### CITY OF SEATTLE ANALYSIS AND DECISION OF THE DIRECTOR OF THE DEPARTMENT OF PLANNING AND DEVELOPMENT

Project Number: 3012542  
Applicant: Dawn Bushnaq of Bushnaq Studio  
Address: 2217 3<sup>rd</sup> Avenue

Land Use Application to allow a 7-story, 51,500 sq. ft. structure with 49 residential units located above 3,600 sq. ft. of retail space at ground level. Two car-share parking stalls to be provided at grade.

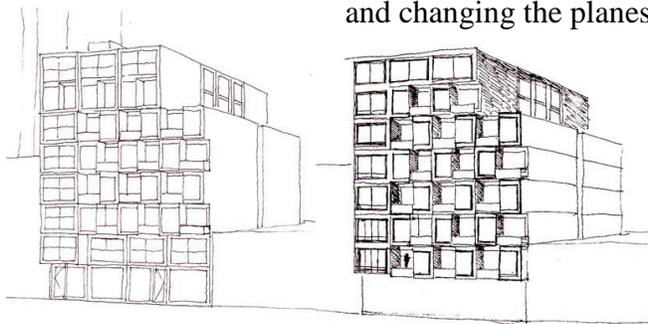
At the Early Design Guidance Meeting, the Board discussed the appearance of the street-facing façade for Alternate 3. The upper level units were shown stepped back from the north property line, and the Board felt that this didn't contribute to a well-proportioned street facing façade. The Board suggested reorganizing the upper level floor plan to create a consistent street-facing façade, similar to Alternate 2. Overall, the Board was supportive of the preferred Alternate 3 with this modification.

The Board expressed appreciation for the preliminary façade sketches for Alternate 3 and they looked forward to seeing more detail at the Recommendation stage. The Board directed the applicant to design the variations in the façade to provide real physical depth and variation within the modules, and use different colors or materials to express the variations. The challenge will be to use colors/materials/shapes to create a unified design across the modules.
